ADDENDUM # 1 Questions and Clarifications

Administration Building HVAC Renovation IFB #FED2019-02

**Greater Peoria Mass Transit District (GPMTD/CityLink)
Administration Building HVAC Renovation**

Addendum 01

Sheet MD1.0 – BASEMENT MECHANICAL DEMOLITION PLAN

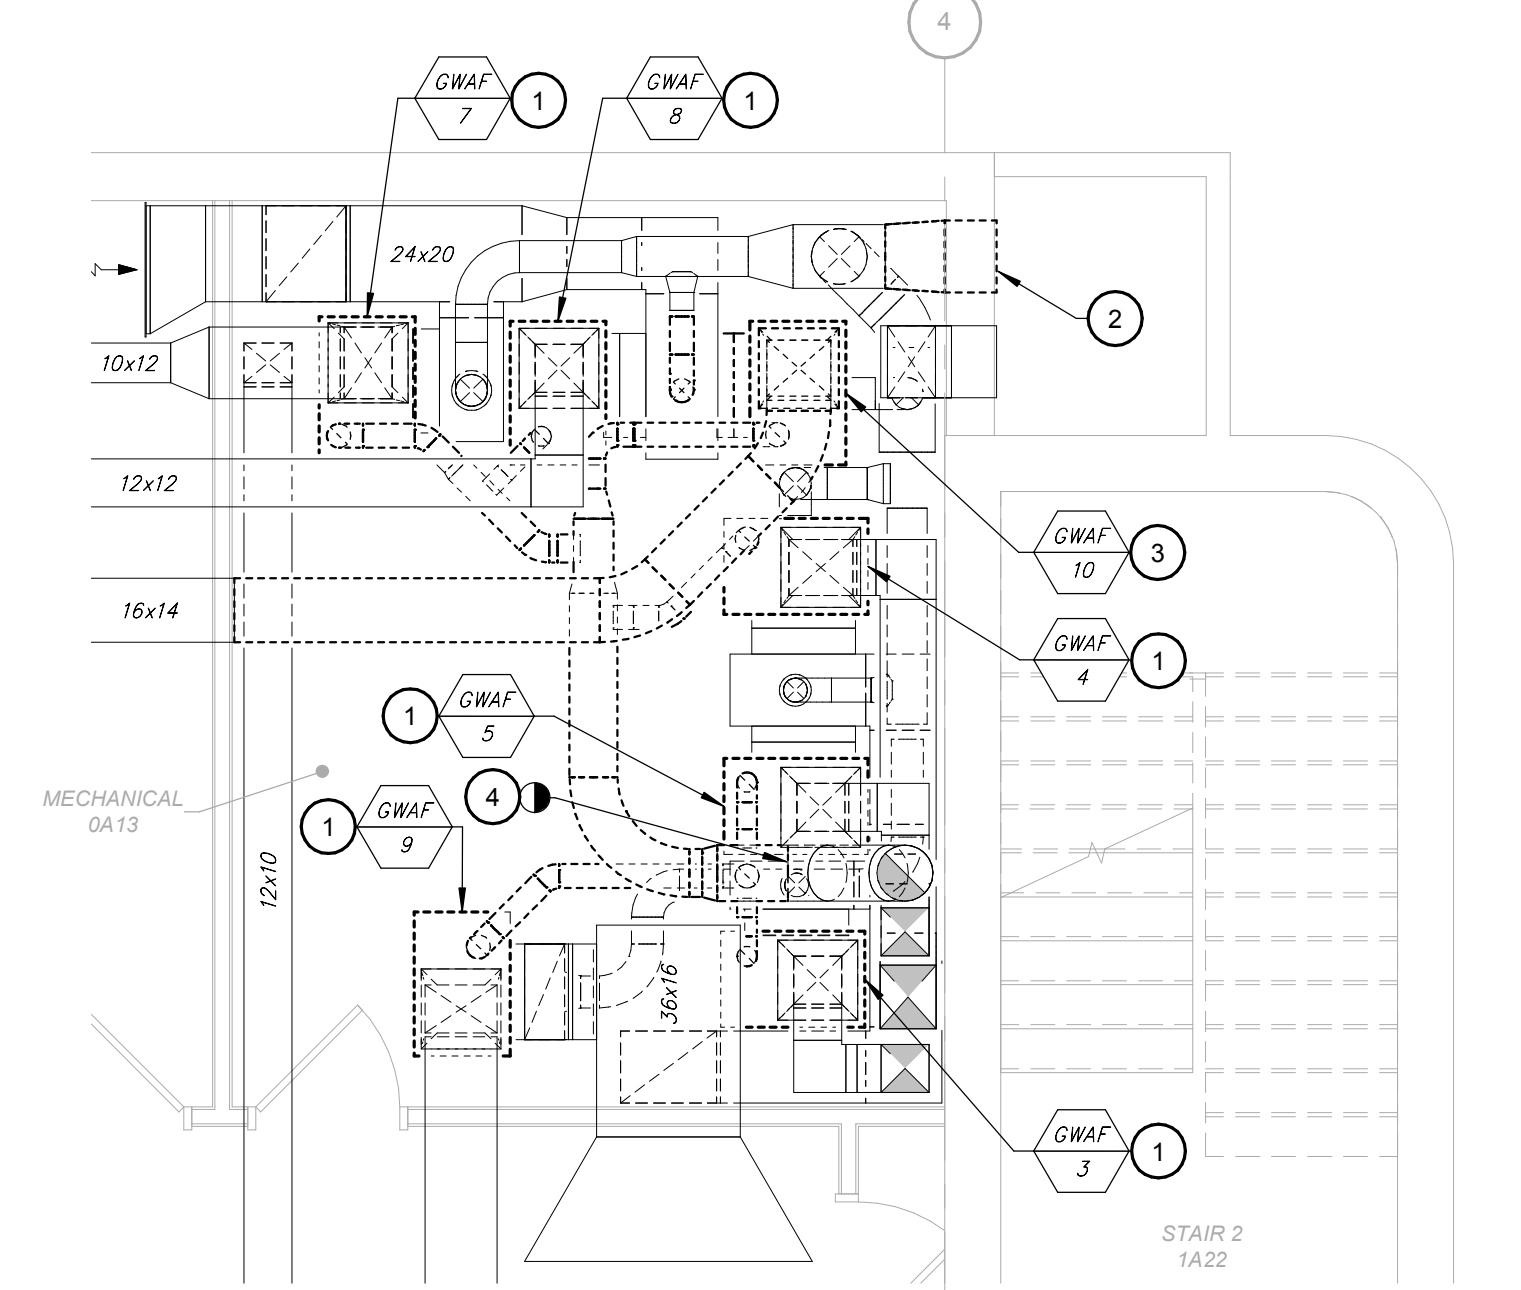
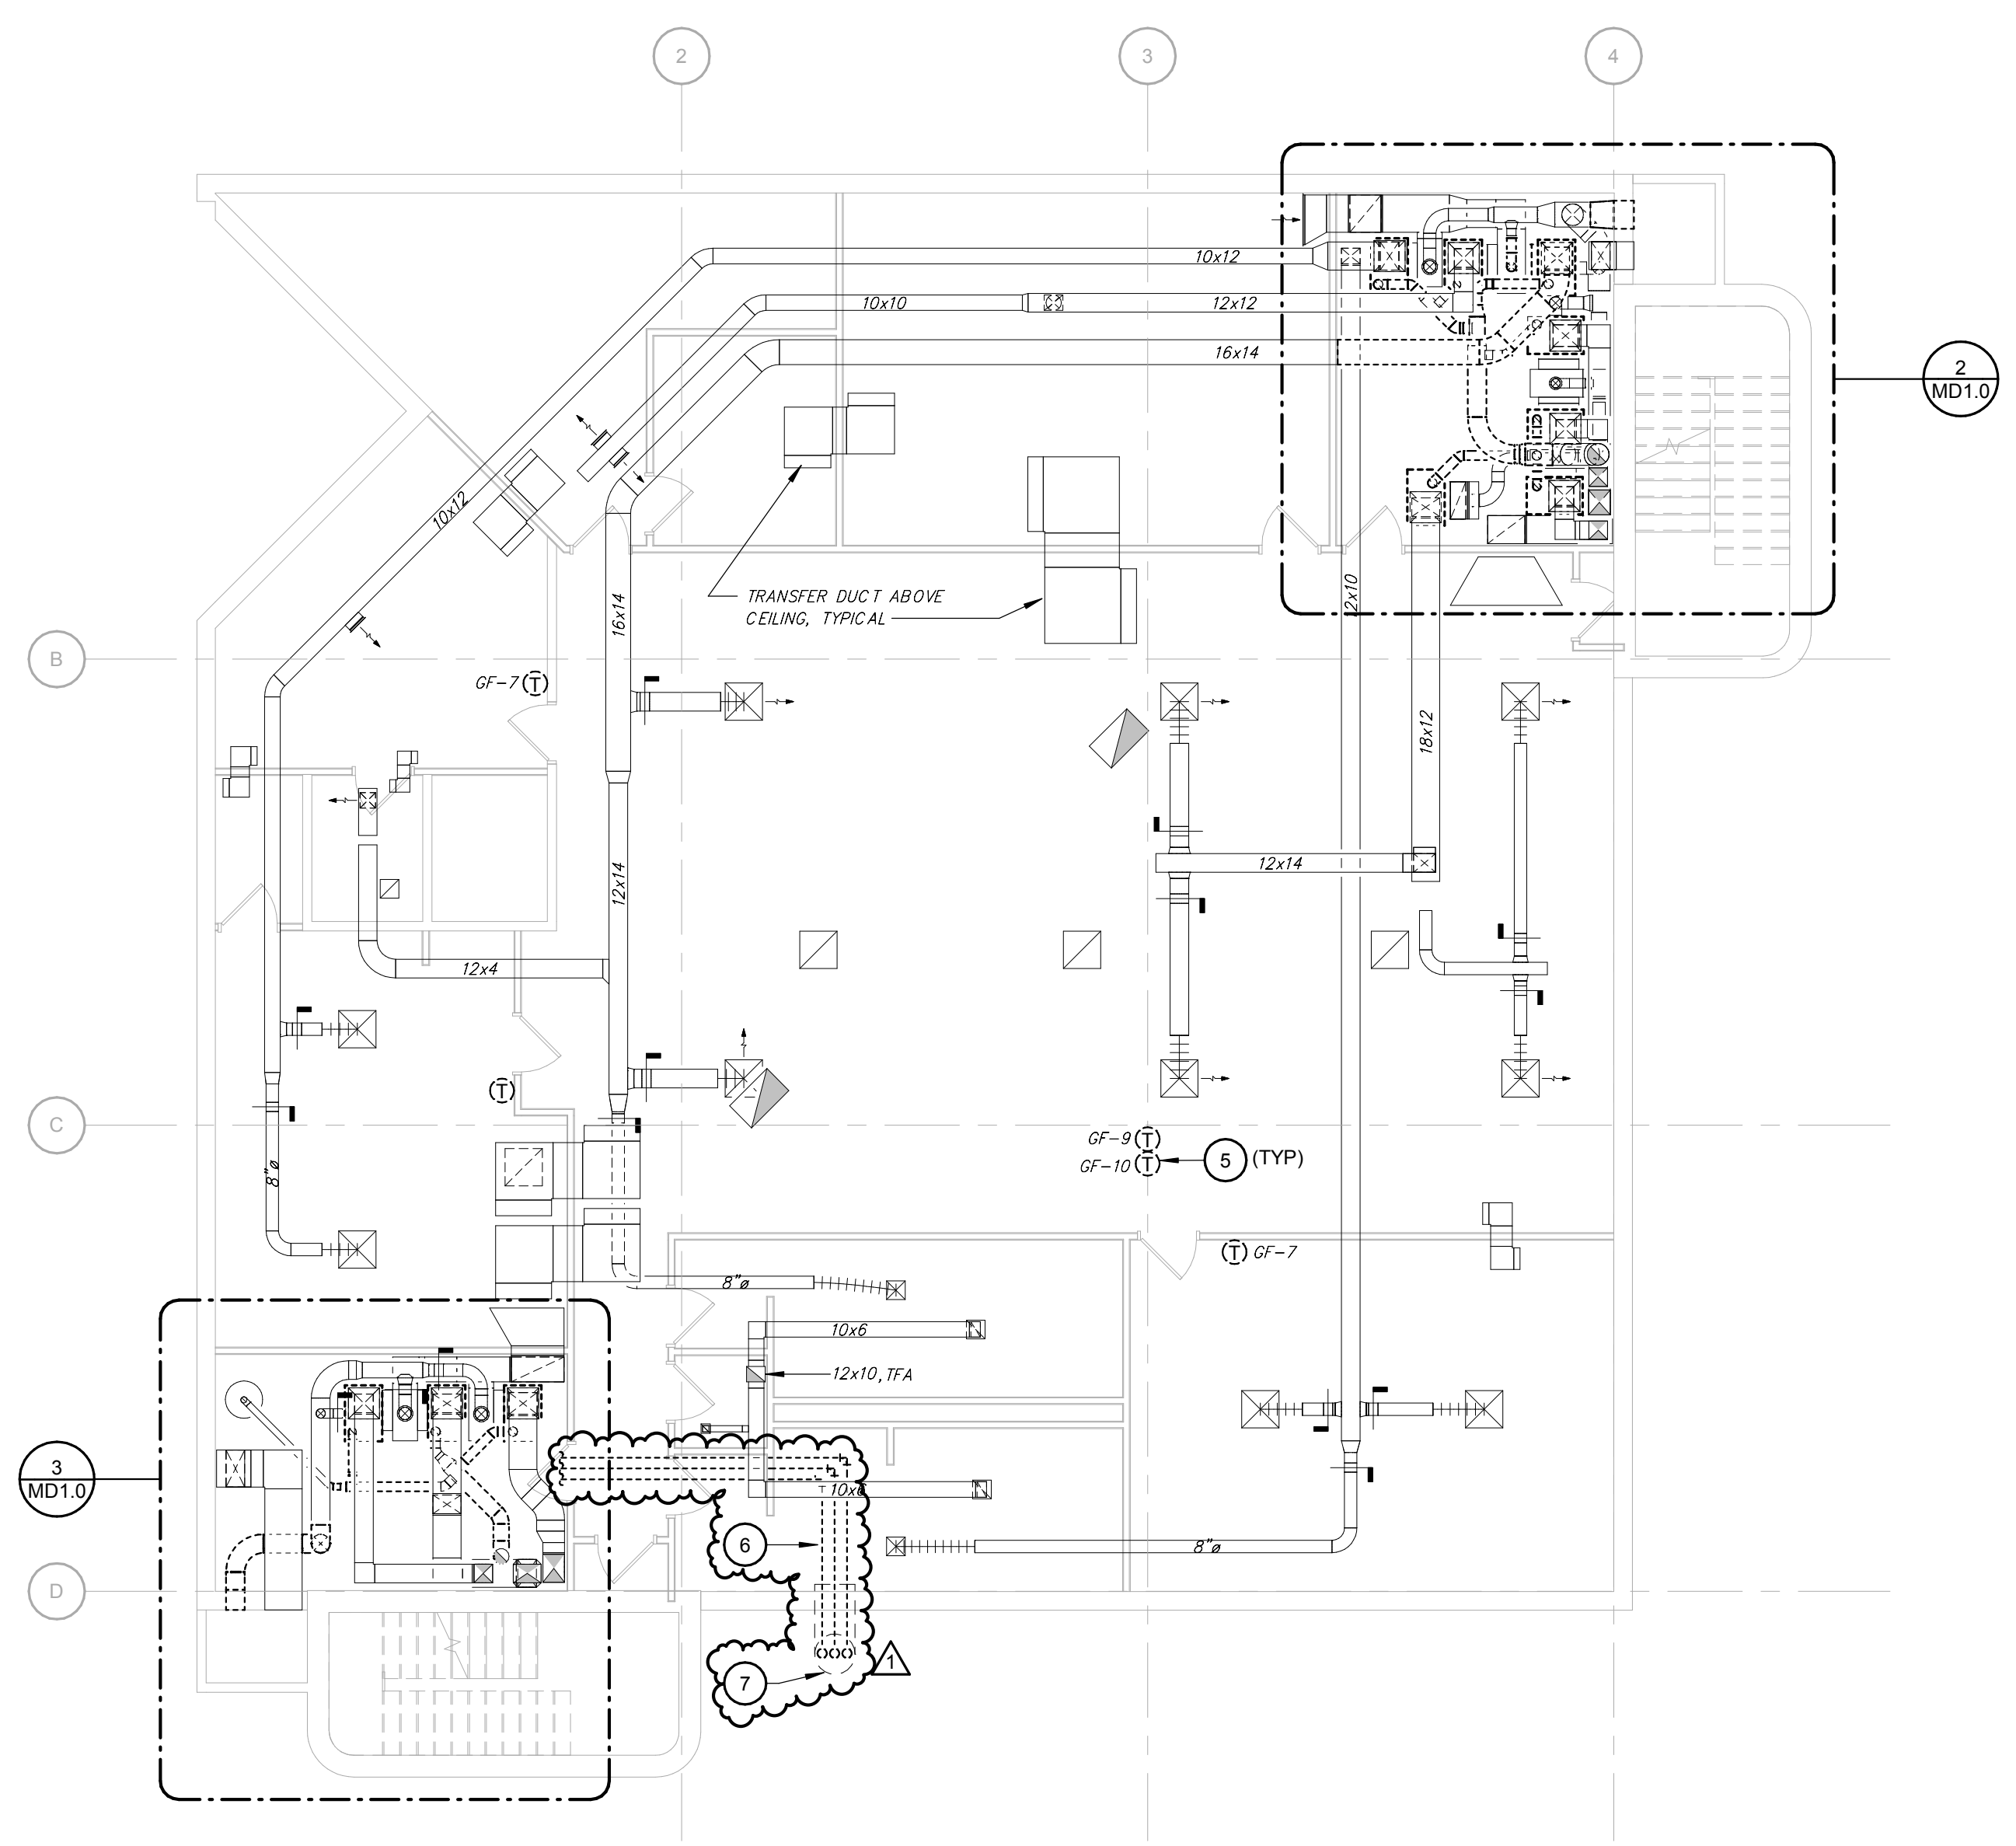
1. REVISION: Revise Basement Mechanical Demolition Plan per attached MD1.0.
2. REVISION: Added Keynotes 6 and 7.
3. REVISION: Modified extent of existing flue demolition.

- 6 REMOVE RLRS TO CONDENSING UNITS ON GRADE. COORDINATE RESTROOM GYPSUM CEILING REMOVAL AND REPAIR FOR ACCESS TO LINESETS.
- 7 PIPE TUNNEL TO GRADE ABOVE.

Sheet MD1.1 – FIRST FLOOR MECHANICAL DEMOLITION PLAN

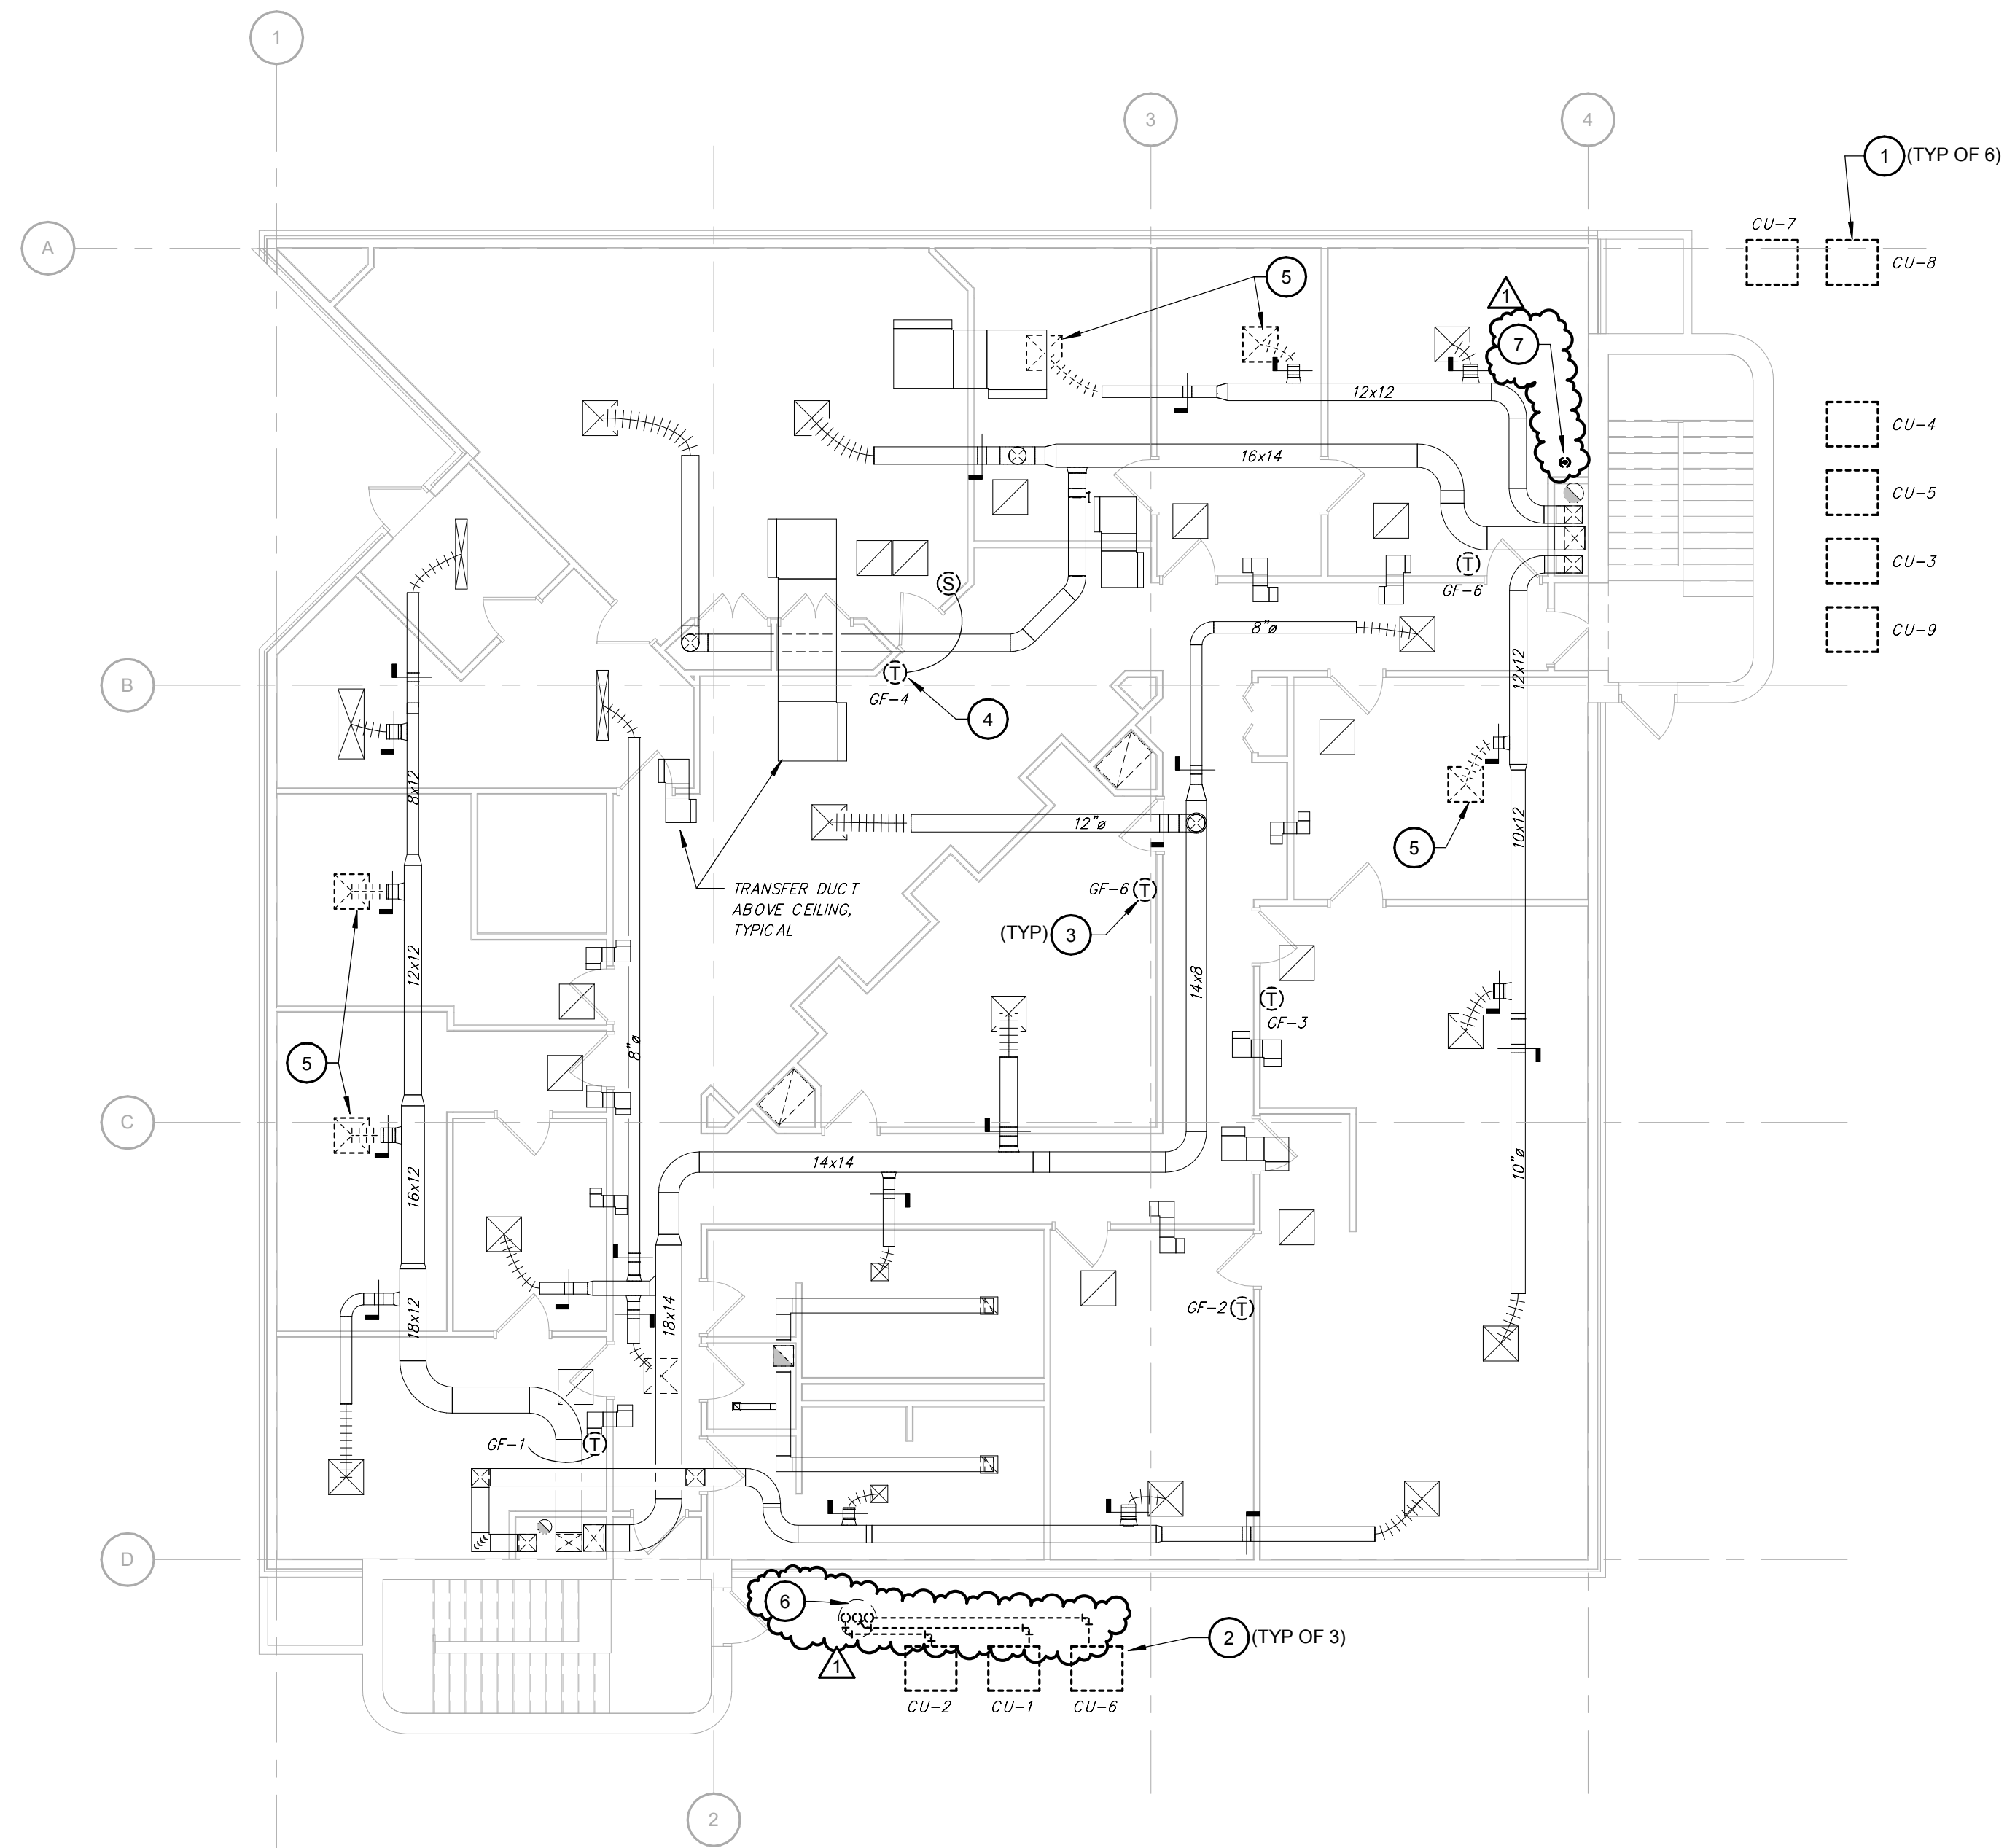
1. REVISION: Revise First Floor Mechanical Demolition Plan per attached MD1.1.
2. REVISION: Added Keynotes 6 and 7 and associated scope.
